Roading/Traffic Evidence - Oliver Brown MWH

Private Plan Change 26 – Westpark
Rangiora Limited, Lehmans & Oxford
Roads, Rangiora

STATEMENT OF EVIDENCE BY OLIVER GREIG KILFORD BROWN

on behalf of the Waimakariri District Council

Westpark, Rangiora
Outline Development Plan
183

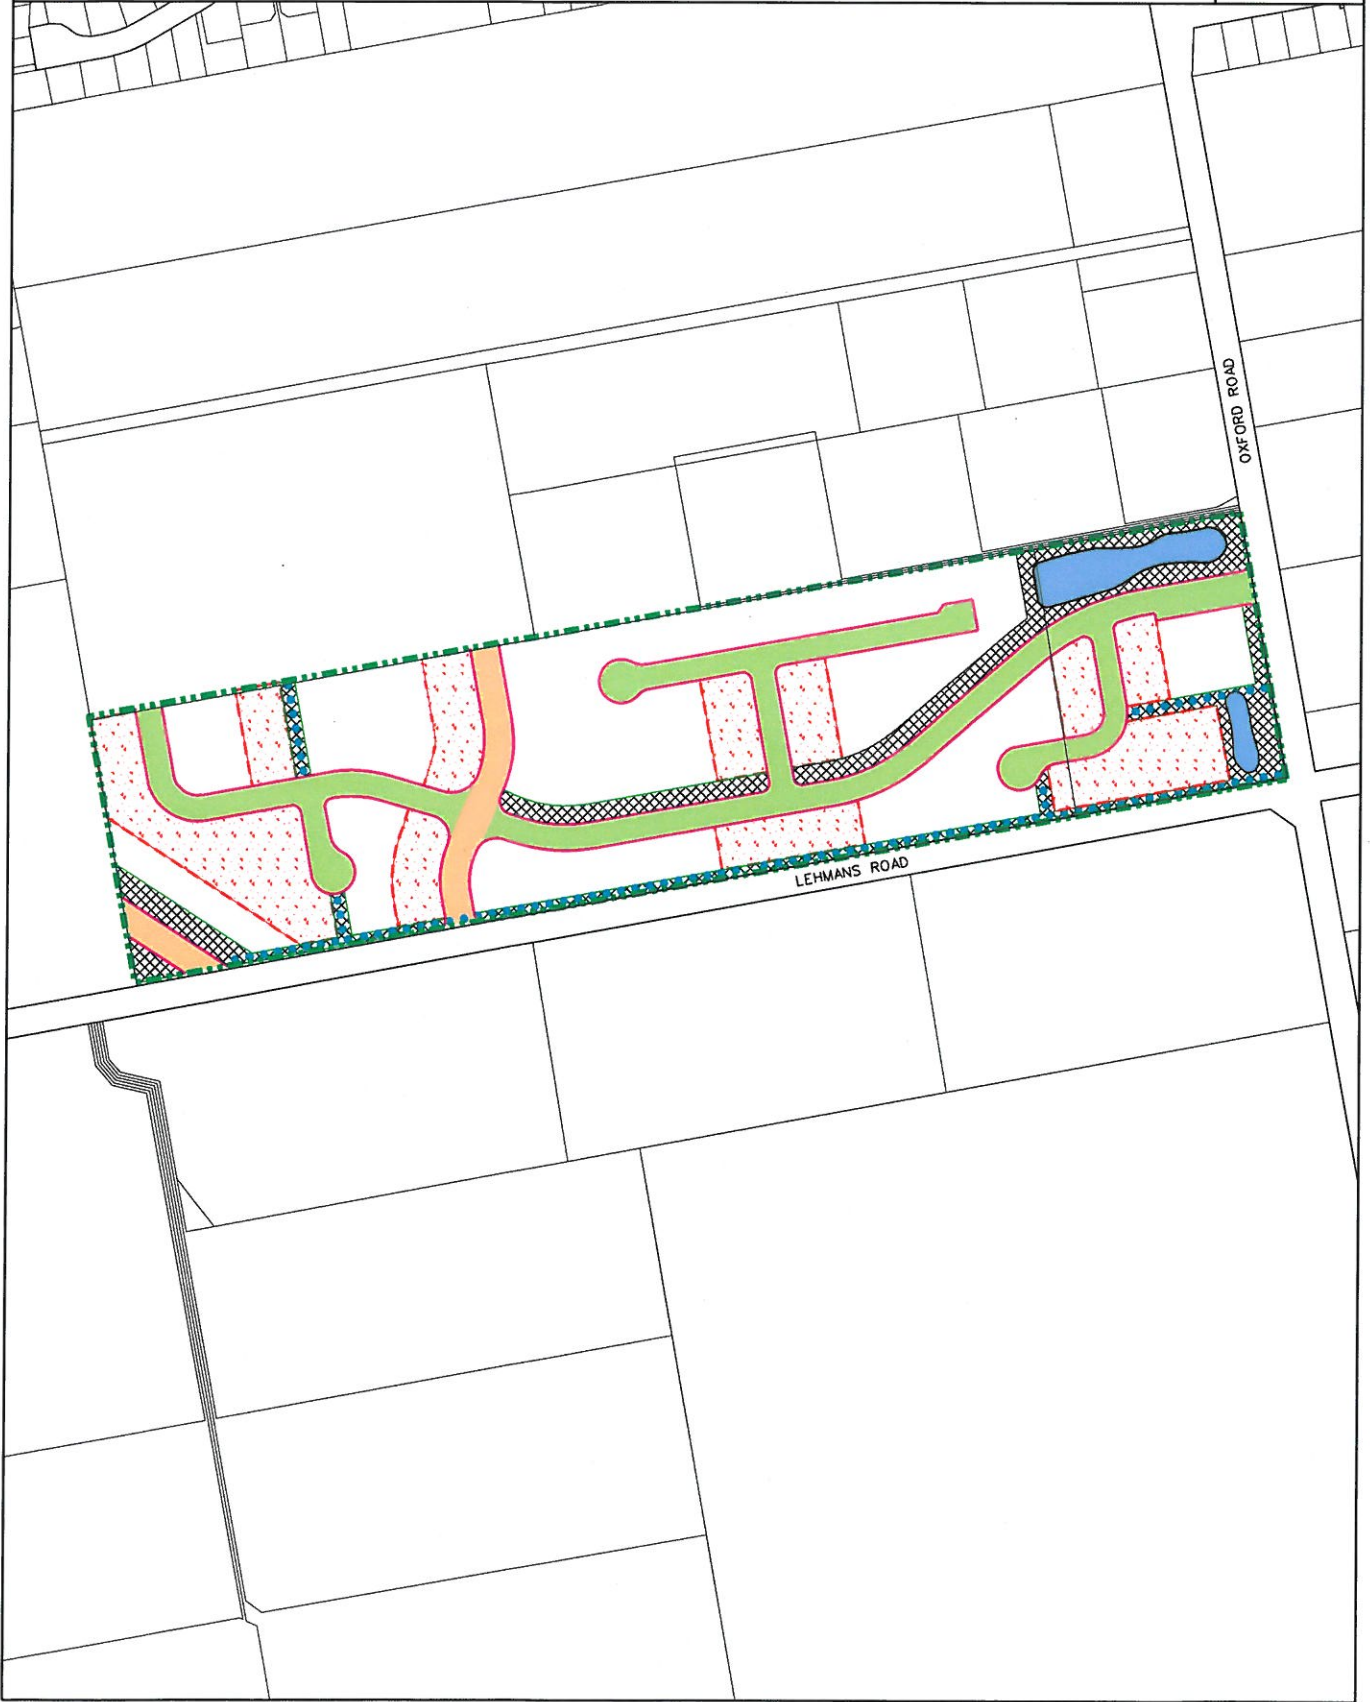
13. The **Outline Development Plan (ODP)** presents one north-south local road linking Oxford Road to the internal east-west urban collector road, and continuing north-east connecting to the PO18 north-south urban collector road. There are four cul-de-sacs linking to the north-south local road.

18. A 20 metre wide road reserve with an additional 5 metre wide recreation reserve is proposed for Lehmans Road. It is possible that the recreation reserve will need to cater for equestrian activity from south of Oxford Road with Rangiora Racecourse and Ashley River located further north. The 5 metre reserve is likely to be too narrow to safely cater for mixed equestrian, walking and cycling.

20. Therefore, from a traffic perspective, a 5.0 metre wide minimum recreation reserve is recommended for pedestrian and cycle use only, and a 10 metre wide recreation reserve provided if equestrian use is anticipated. The greater width would also be consistent with the WRSP, which presents a 10 metre wide recreation reserve.

22. No connection is proposed to the Brick Kiln Lane group of properties east of Westpark. It is recommended that a road corridor is provided from the eastern most north-south local road to the Westpark boundary by extension of the east-west local road. This link ensures future connectivity and is consistent with the link detailed on the PO18 ODP. In the interim, this could be a pedestrian and cycle link, as discussed below.

23. A range of Pedestrian and Cycle links and facilities are indicated on the ODP and typical road cross sections and these appear appropriate. The connections from cul-de-sac heads to adjacent roads and connection to the PO18 subdivision are strongly supported. Connections should also be provided from the eastern most north-south cul-de-sacs north to the proposed east-west collector, south to the stormwater management area and east towards Brick Kiln Lane.

24. The local purpose reserve on the northern side of Oxford Road will cater for pedestrians and cyclists, however there is no connection further east to the PO18 subdivision and to the existing footpath on Oxford Road as detailed in the WRSP. A suitable connection along the northern side of Oxford Road to the PO18 subdivision boundary is required in conjunction with this development at the time of subdivision. Also of note, but outside the scope of this application, is that the local purpose reserve detailed in the WRSP on the northern side of Oxford Road is not provided adjacent PO18 between the north-south collector and the western boundary. This will be required to ensure future connectivity.

80 The ODP provides no connectivity in this area, and my assessment identified and recommended the ODP be amended to provide a road corridor from the eastern most north-south local road to the Westpark boundary by extension of the east-west local road. This is to ensure future connectivity for all modes.

- 61 The 5 metre wide recreation reserve proposed for Lehmans Road is considered too narrow to safely cater for mixed equestrian, pedestrian and cycle use and limits Councils landscaping options if considering solely pedestrians and cyclists. From a traffic perspective, reserve should be 5.0 metres wide if catering for pedestrians and cyclists only and increased to 10 metres wide if catering for equestrians. The greater width is consistent with the WRSP.

- 65 A transport connection is required east to the Brick Kiln Lane area to ensure future connectivity for all modes is maintained.
- 66 Land requirements for the proposed Lehmans Road bypass require confirmation to ensure sufficient area is provided to permit implementation of a compliant collector road.
